ADDENDUM NO. 01

CITY OF PORT ARANSAS CITY HALL / CIVIC CENTER EXPANSION AND RENOVATION

TRA PROJECT NO. 2023-29

Issue Date: March 11, 2025

M1.3

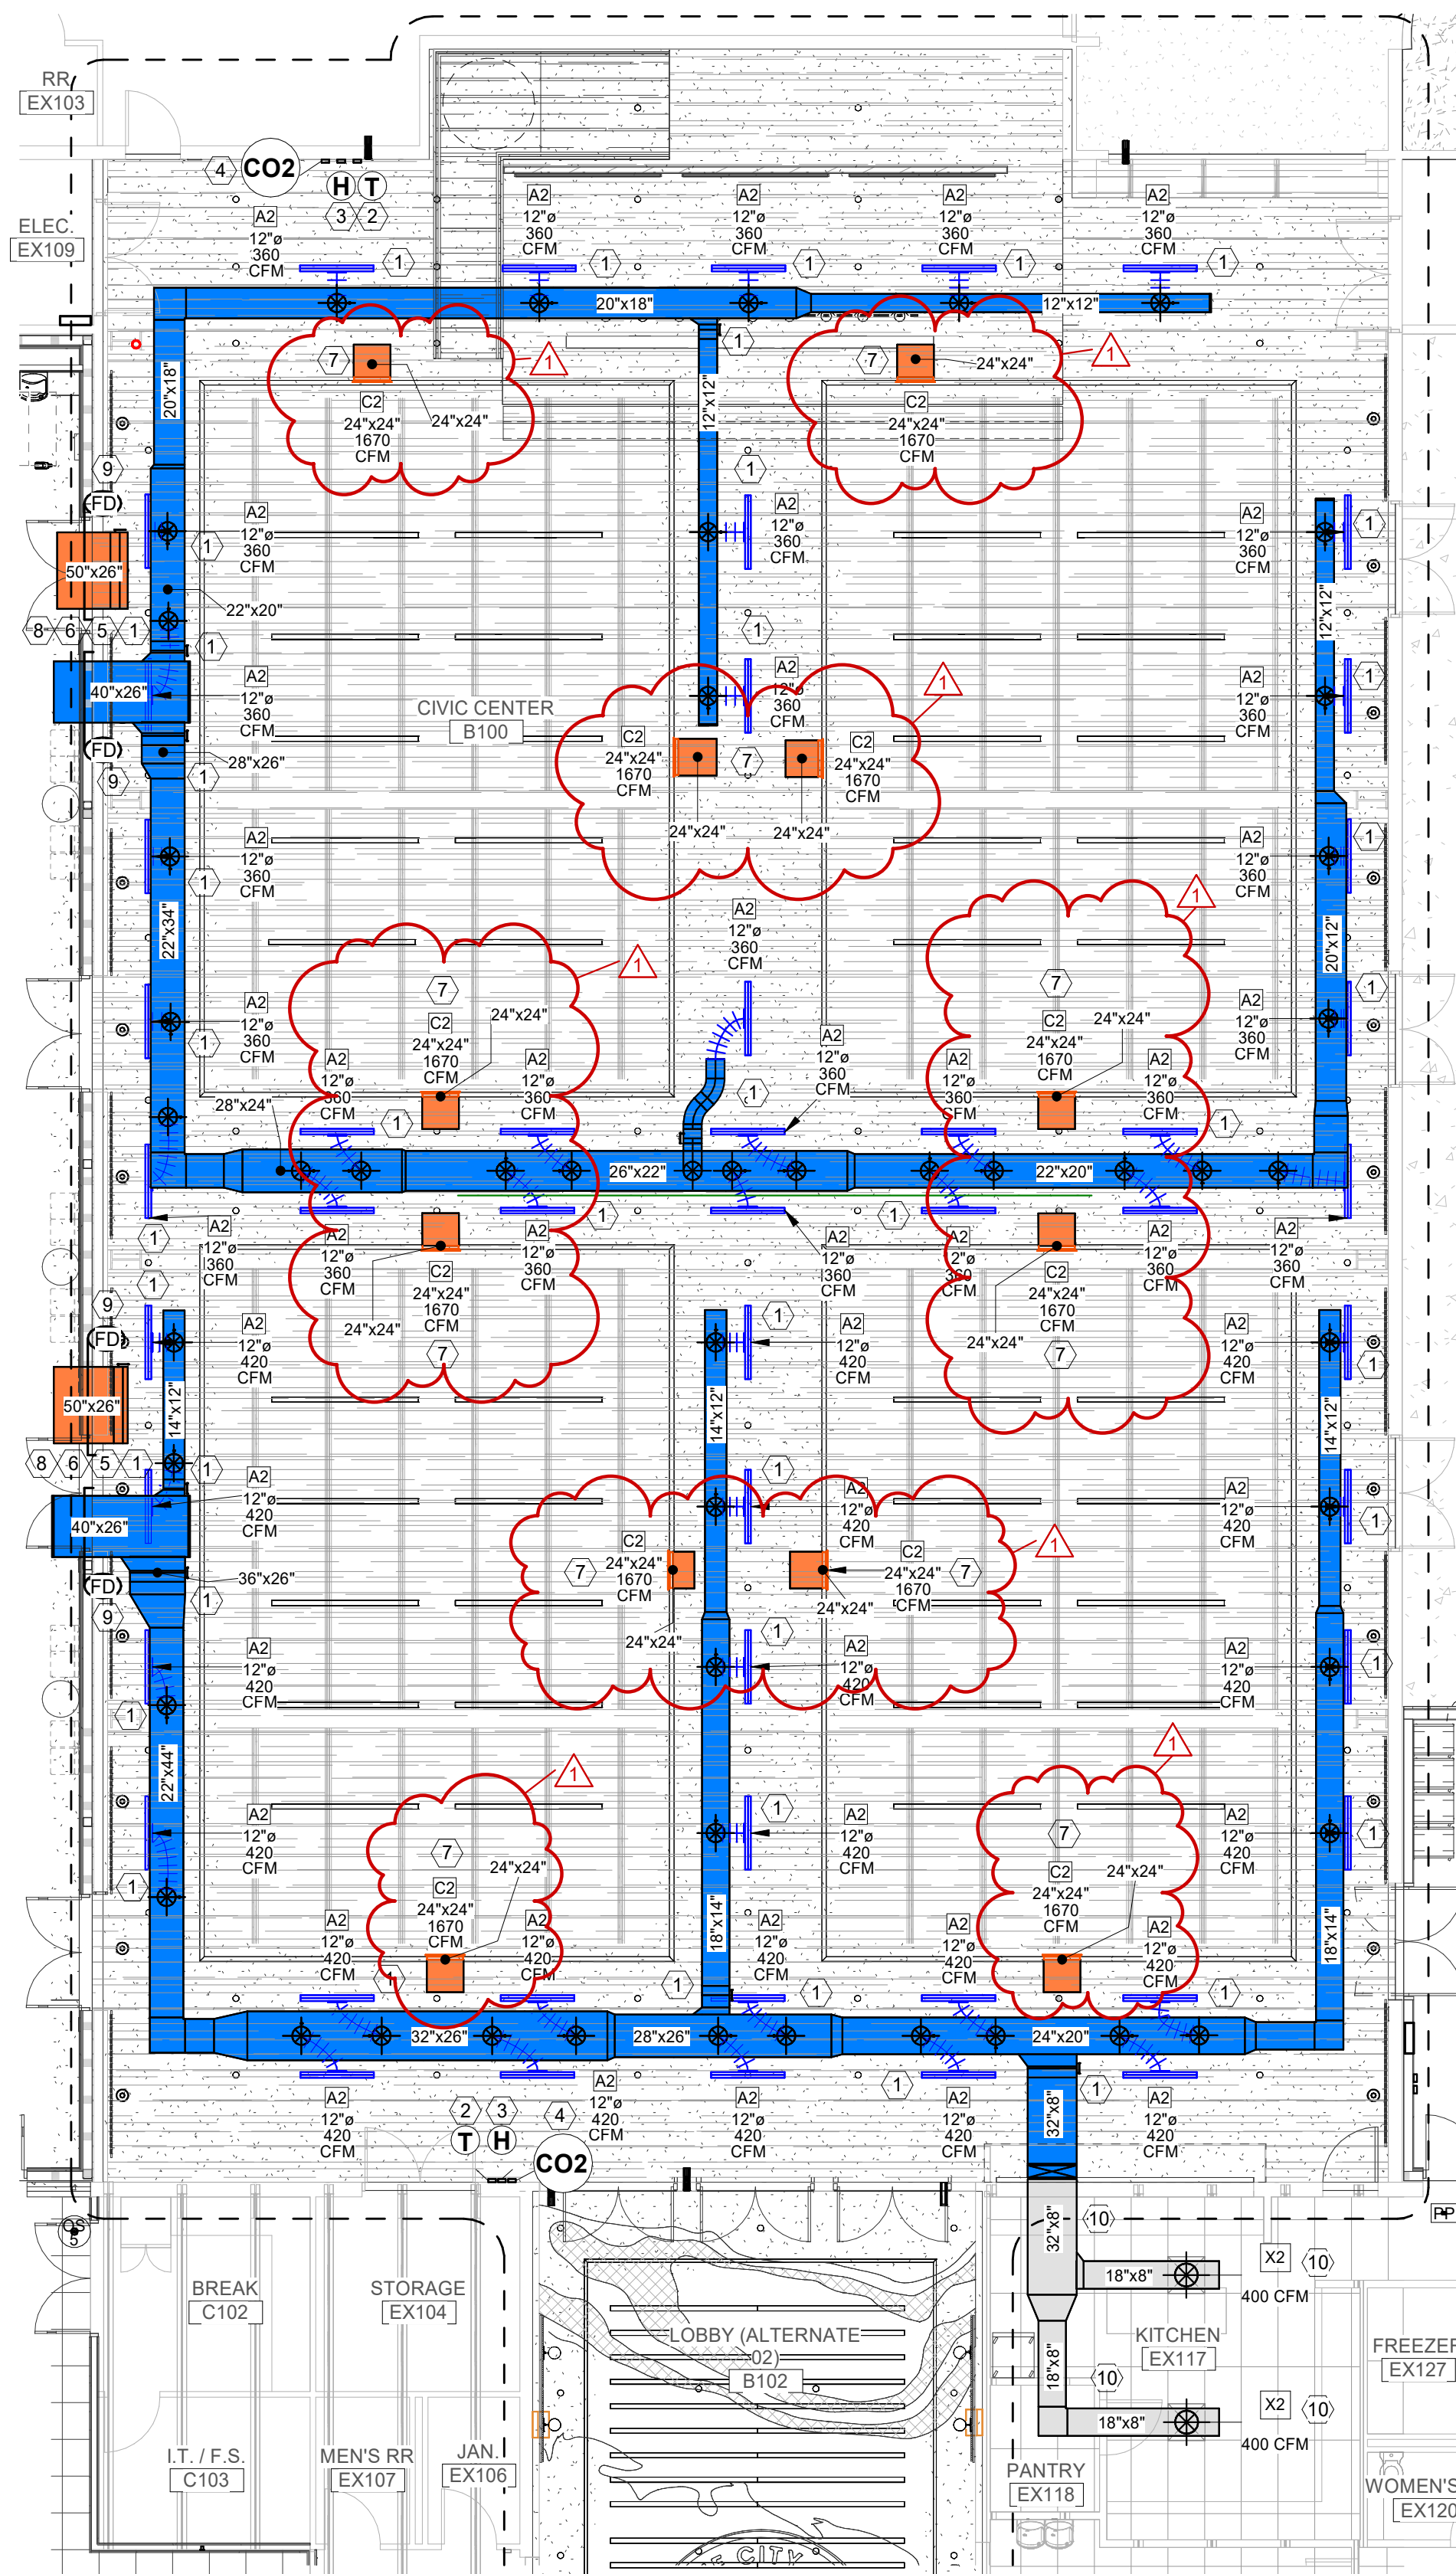
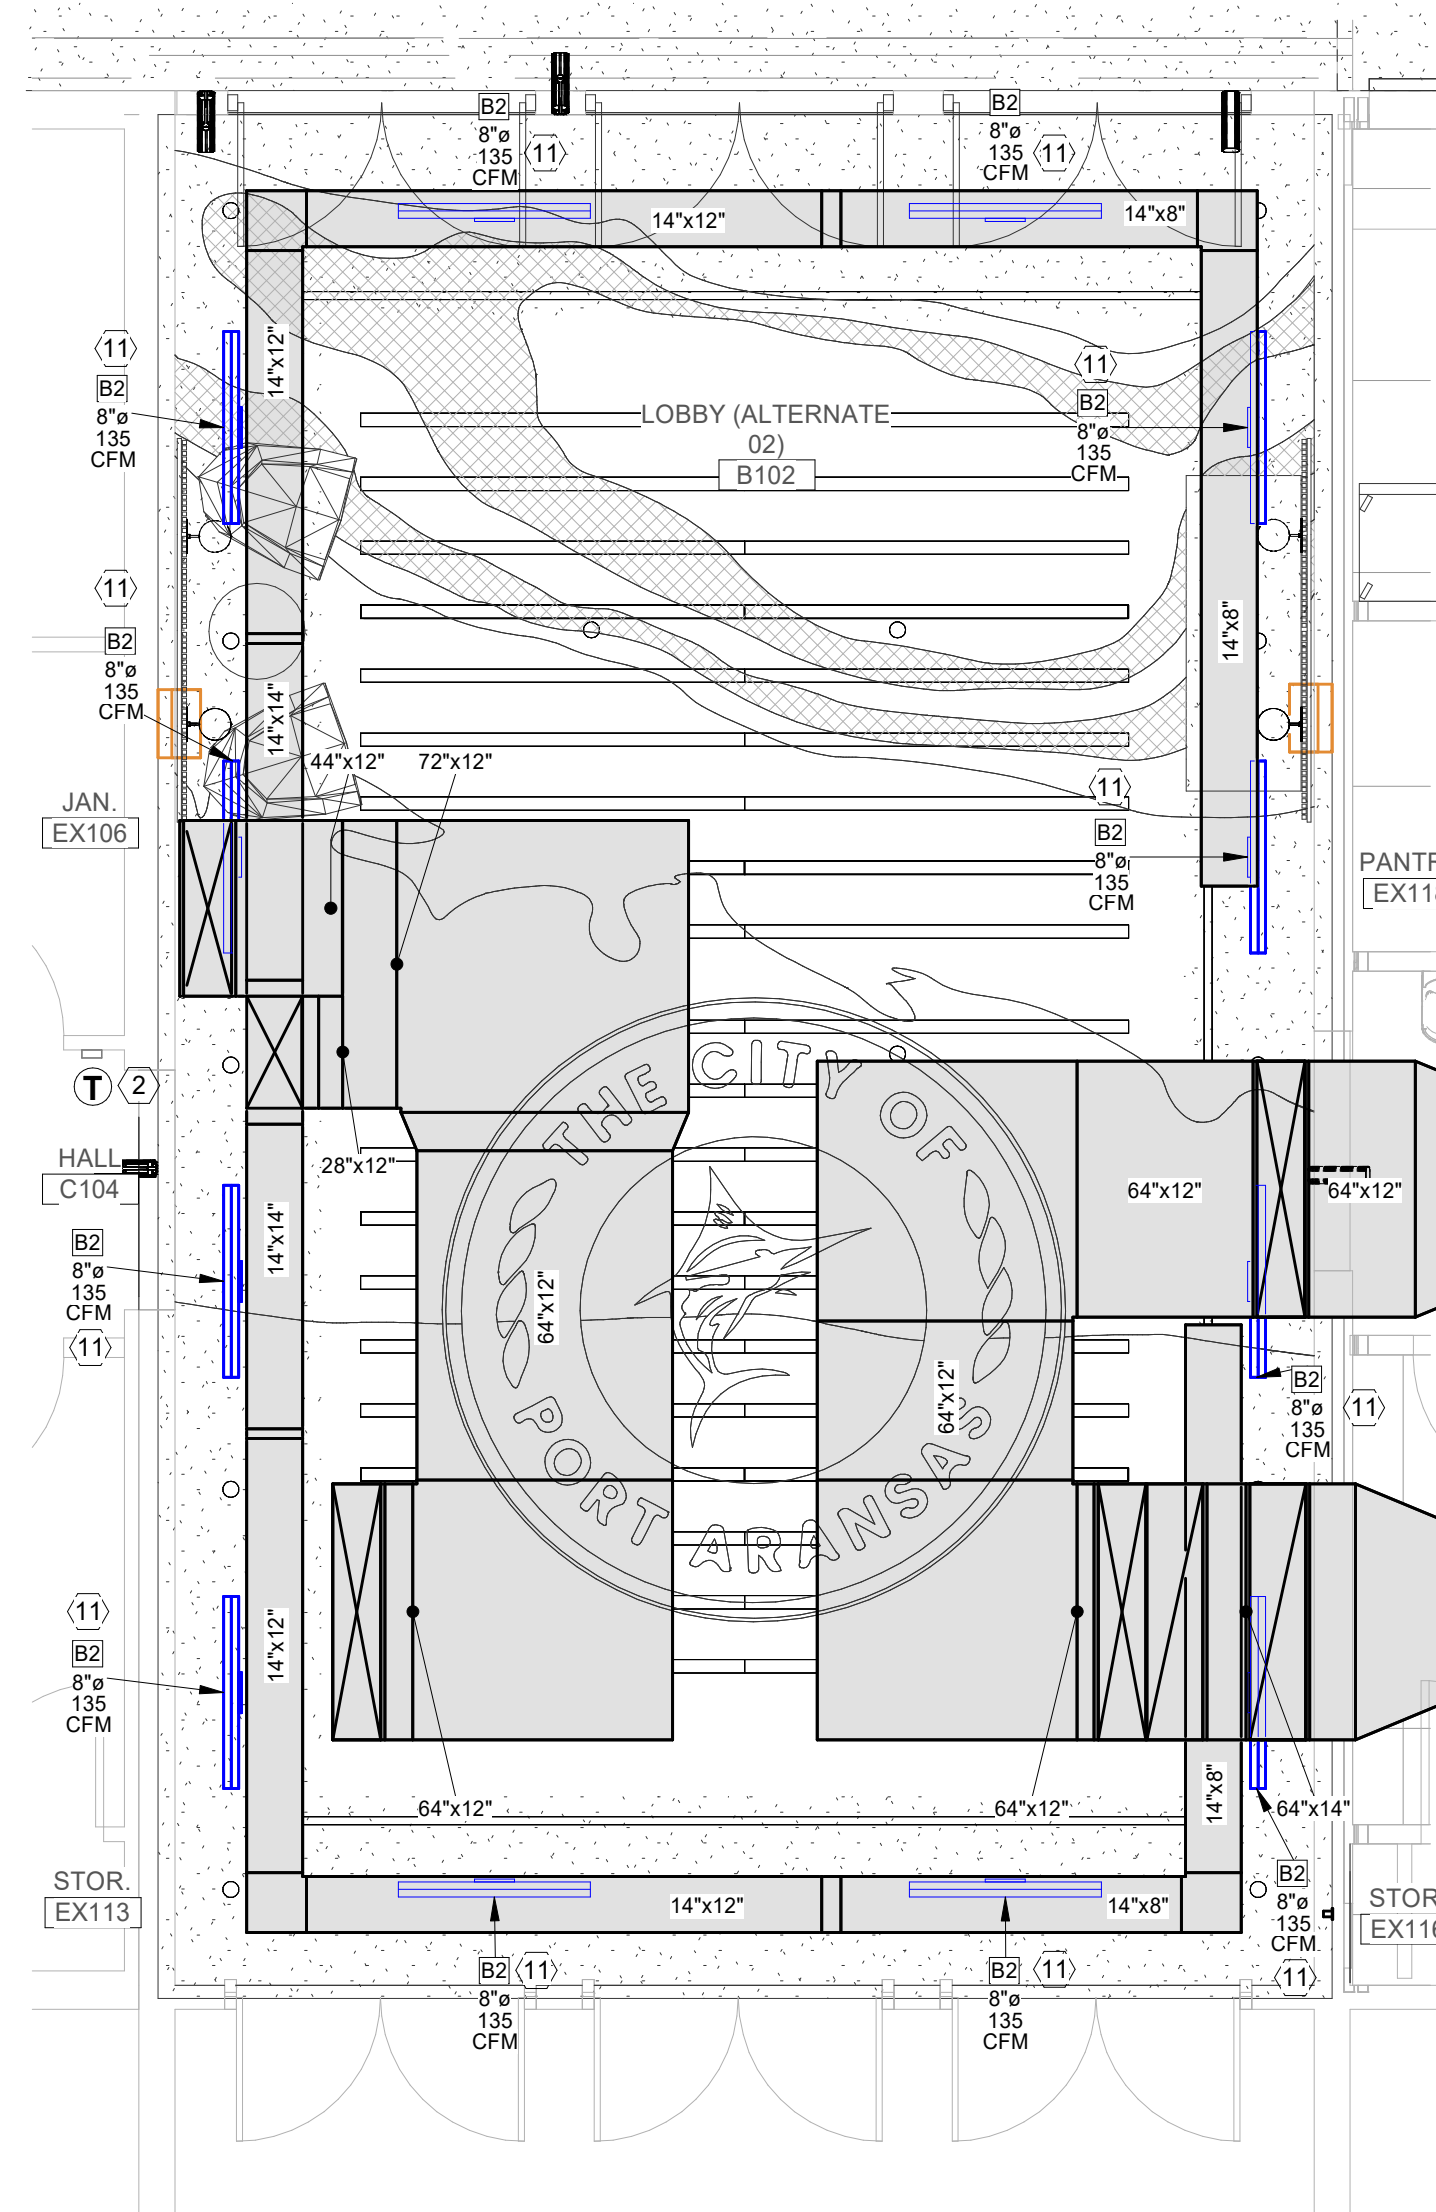
DESCRIPTION: Added fire damper to return transfer grilles. Added keynote 4 to supply linear diffusers.

DESCRIPTION: Added return grilles to return air transfer duct. Updated keynote 7.

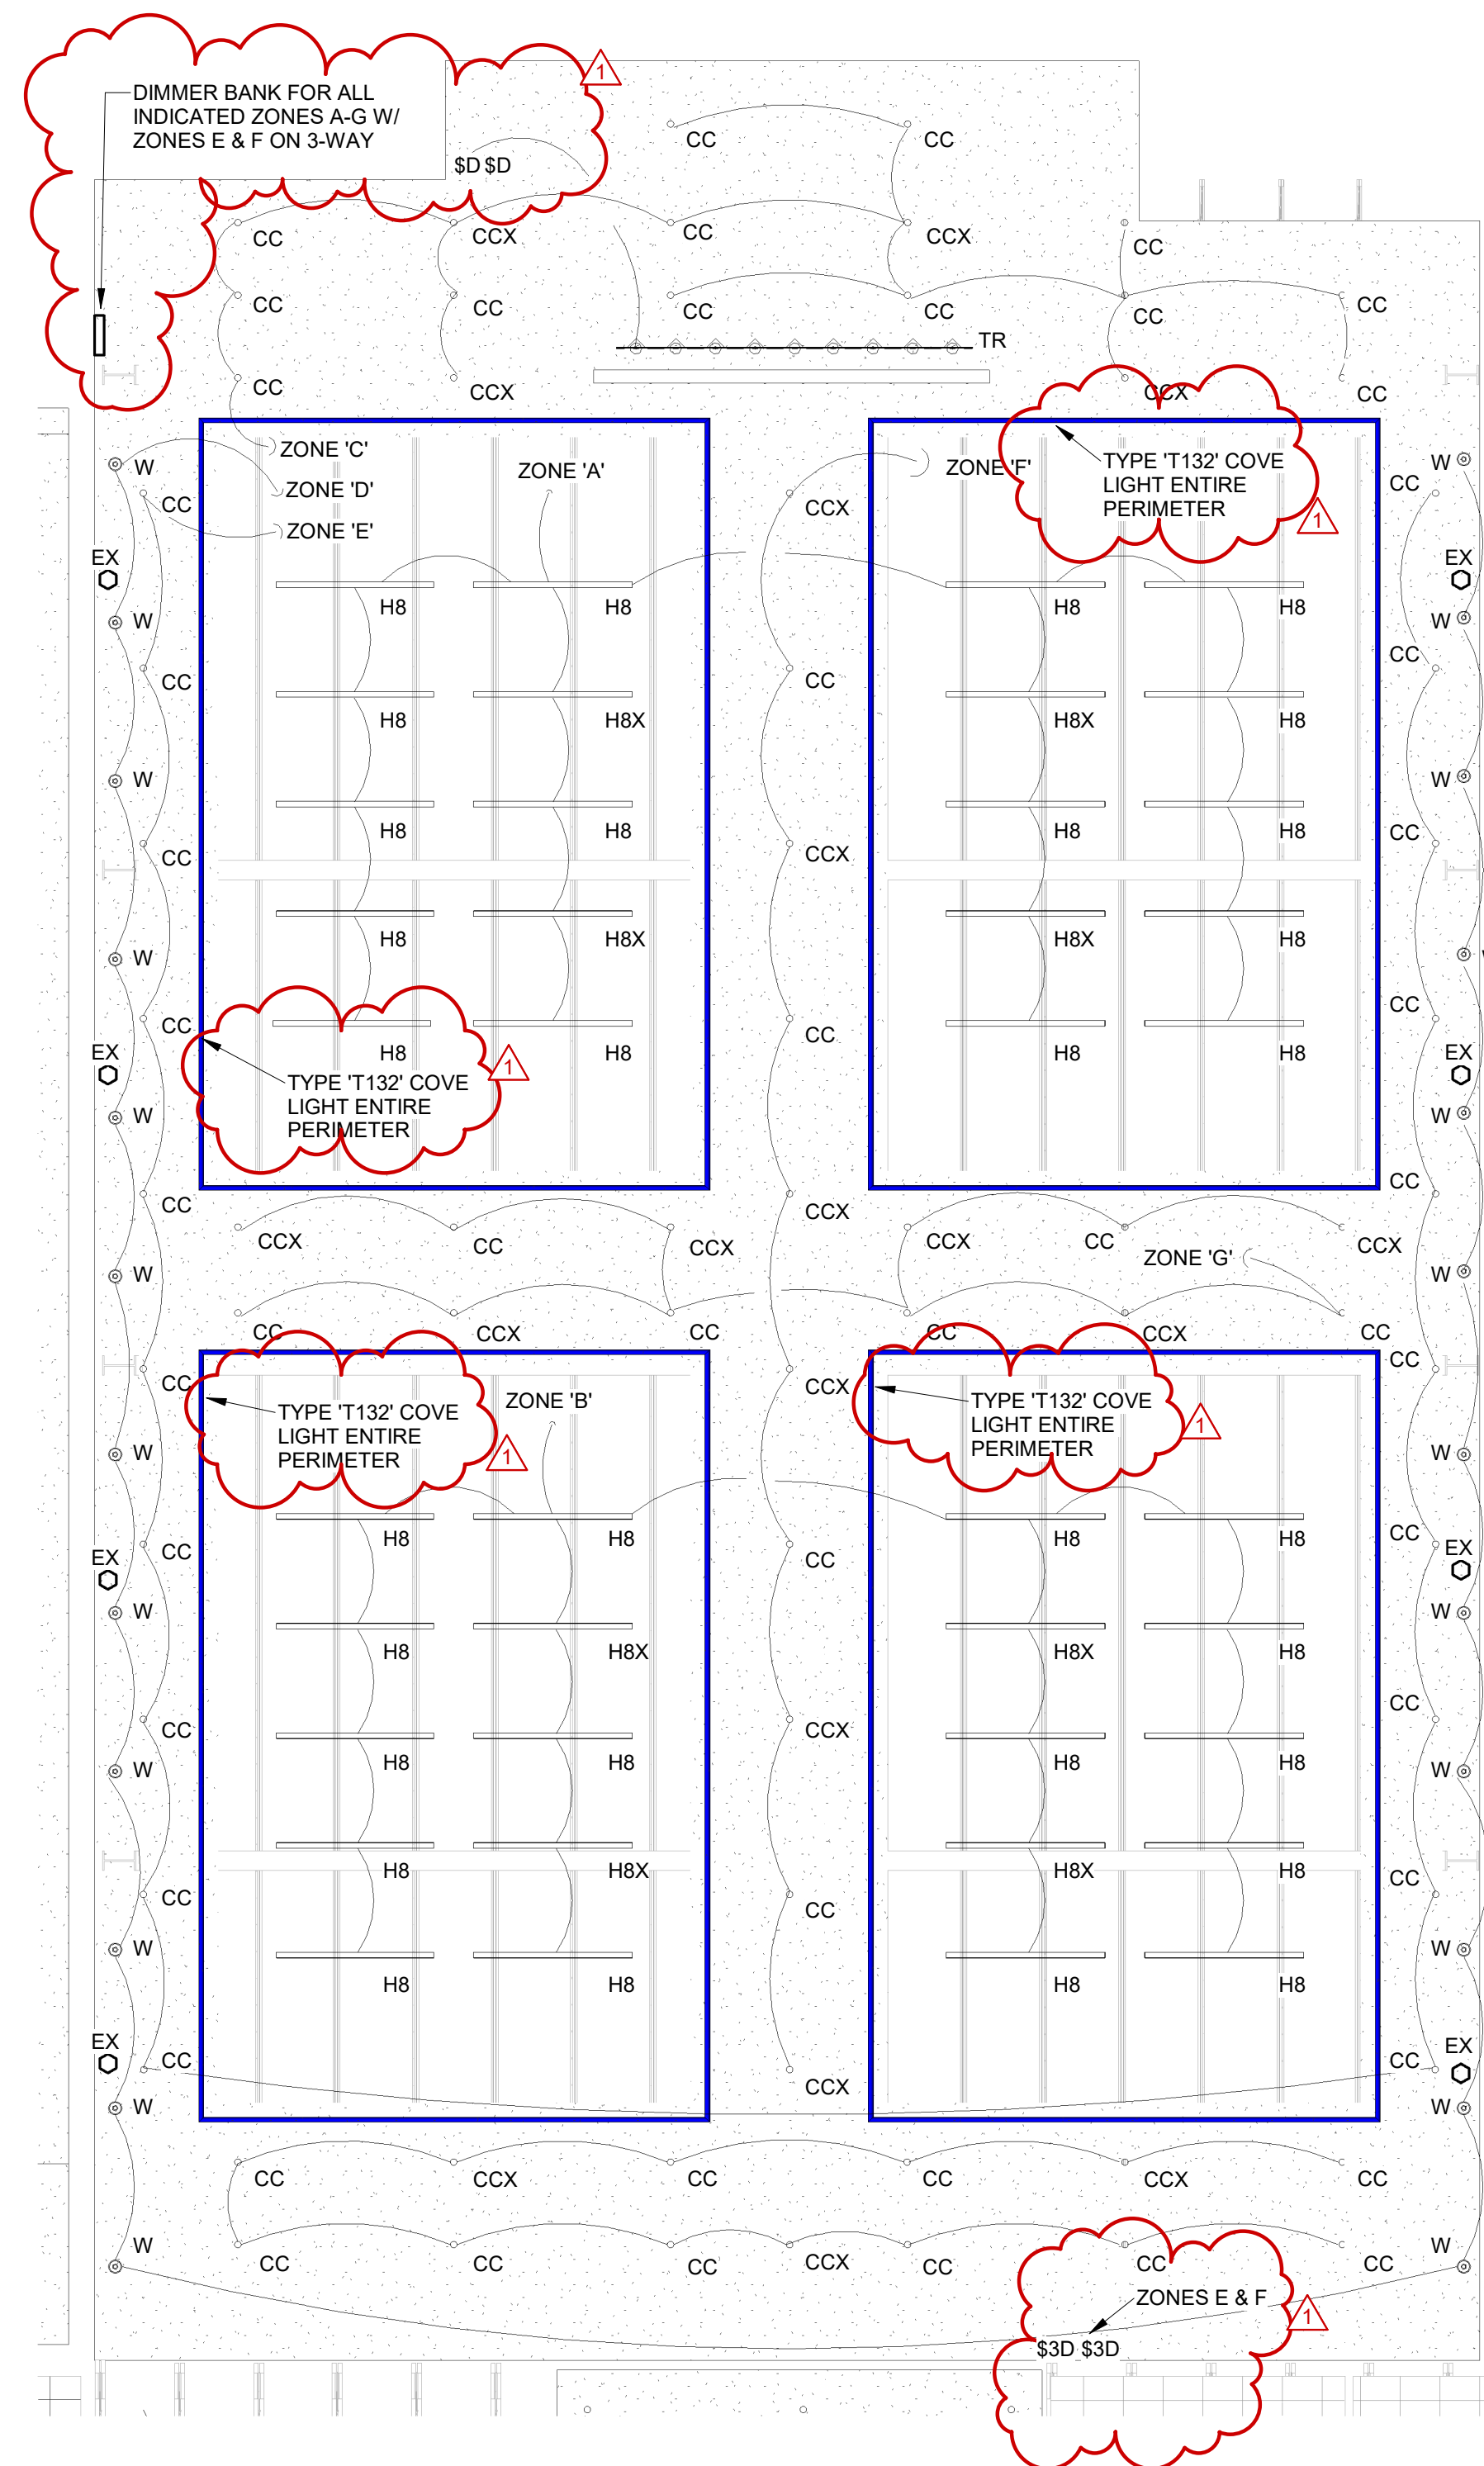
DESCRIPTION: Revised lighting at Lobby and Civic Center.
